Subject: DP-1132, Condition Number 2, Notification of Changes, Technical Area 52 Solar Evaporation Tank System Upgrades

DP-1132 Permit Condition Number 2, Notification of Changes, Technical Area 52 Solar Evaporation Tank System Upgrades

Solar Evaporation Tank System Site Plan

RADIOACTIVE LIQUID WASTE TREATMENT FACILITY
 ENLARGED PLOT PLAN

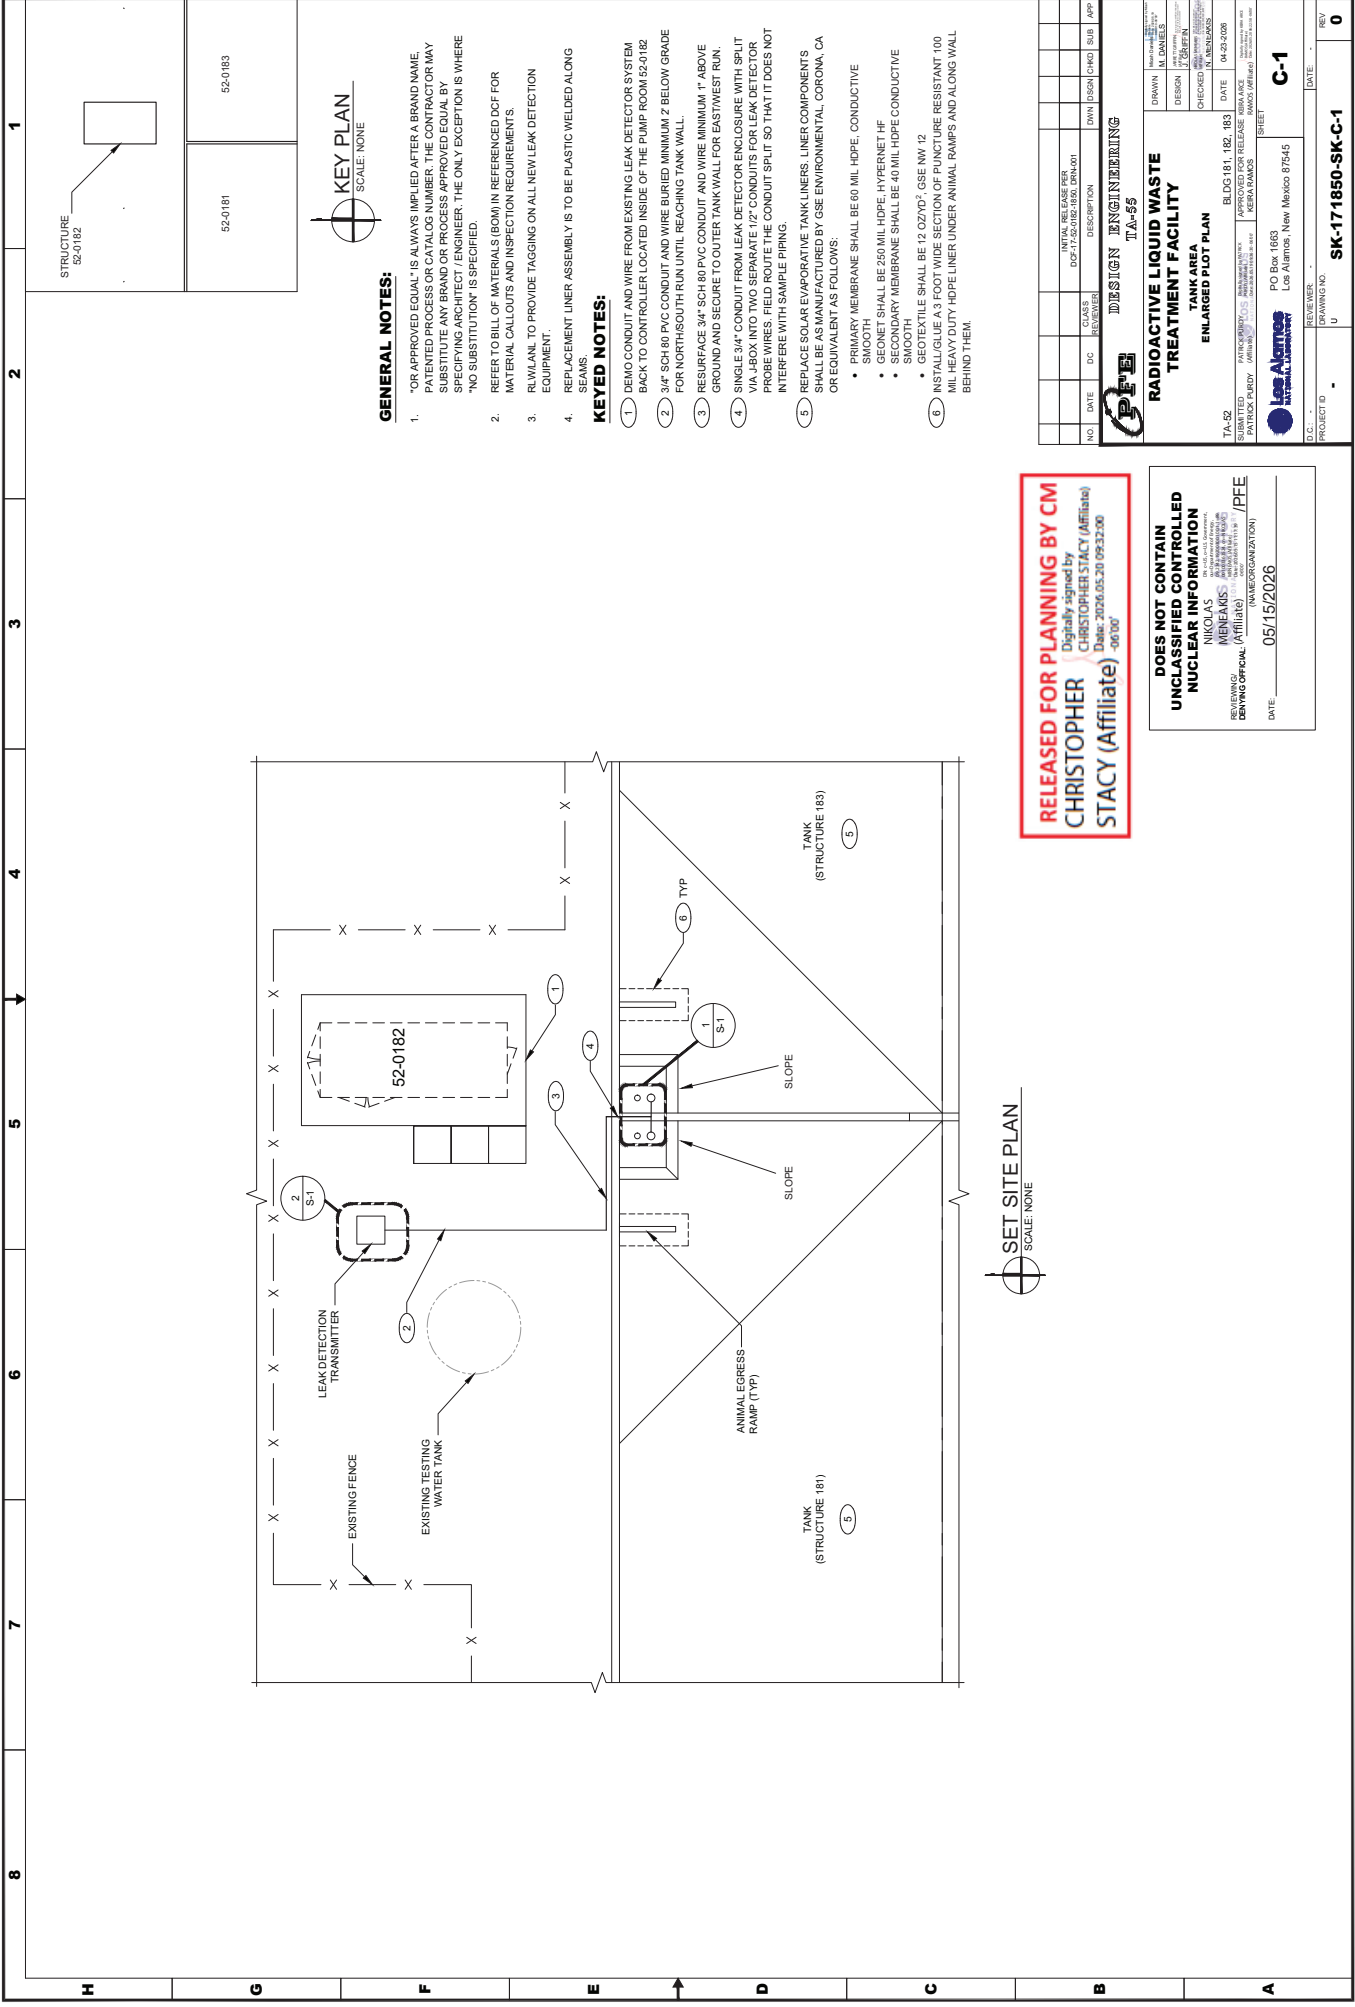
- 1) The two synthetic liners and leak detection system originally installed when the SET was constructed will be replaced with similar equivalent equipment (primary liner: 60 mil high-density polyethylene, secondary liner: 40 mil high-density polyethylene).

- 2) New stainless-steel piping will be installed at the SET. Four-inch stainless steel piping will connect the SET pumphouse with each evaporation basin for transfer of treated effluent from the pumphouse into the evaporation basins. Three-inch stainless-steel piping will connect the SET pumphouse with each evaporation basin for transfer of treated effluent from each basin.

- 3) A new piping spool piece will be installed at the TA-50 RLWTF, enabling isolation and testing of the conveyance line connecting the RLWTF to the SET to facilitate water tightness testing required by Permit Condition Number 8, Water Tightness Testing, to be completed.

Attachment 2 includes the SET Site plan for this project.

1. DEMO CONDUIT AND WIRE FROM EXISTING LEAK DETECTOR SYSTEM BACK TO CONTROLLER LOCATED INSIDE OF THE PUMP ROOM 52-0182
2. 3/4" SCH 80 PVC CONDUIT AND WIRE BURIED MINIMUM 2' BELOW GRADE FOR NORTHSOUTH RUN UNTIL REACHING TANK WALL.

3. RESURFACE 3/4" SCH 80 PVC CONDUIT AND WIRE MINIMUM 1' ABOVE GROUND AND SECURE TO OUTER TANK WALL FOR EASTWEST RUN.
4. SINGLE 3/4" CONDUIT FROM LEAK DETECTOR ENCLOSURE WITH SPLIT VIA J-BOX INTO TWO SEPARATE 1/2" CONDUITS FOR LEAK DETECTOR PROBE WIRES. FIELD ROUTE THE CONDUIT SPLIT SO THAT IT DOES NOT INTERFERE WITH SAMPLE PIPING.

5. REPLACE SOLAR EVAPORATIVE TANK LINERS, LINER COMPONENTS SHALL BE AS MANUFACTURED BY GSE ENVIRONMENTAL, CORONA, CA OR EQUIVALENT AS FOLLOWS:
 - PRIMARY MEMBRANE SHALL BE 60 MIL HDPE, CONDUCTIVE SMOOTH

- GEONET SHALL BE 250 MIL HDPE, HYPERNET HF
 - SECONDARY MEMBRANE SHALL BE 40 MIL HDPE CONDUCTIVE SMOOTH
 - GEOTEXTILE SHALL BE 12 OZ/YD² GSE NW 12
6. INSTALL GLUE A 3 FOOT WIDE SECTION OF PUNCTURE RESISTANT 100 MIL HEAVY DUTY HDPE LINER UNDER ANIMAL RAMPS AND ALONG WALL BEHIND THEM.
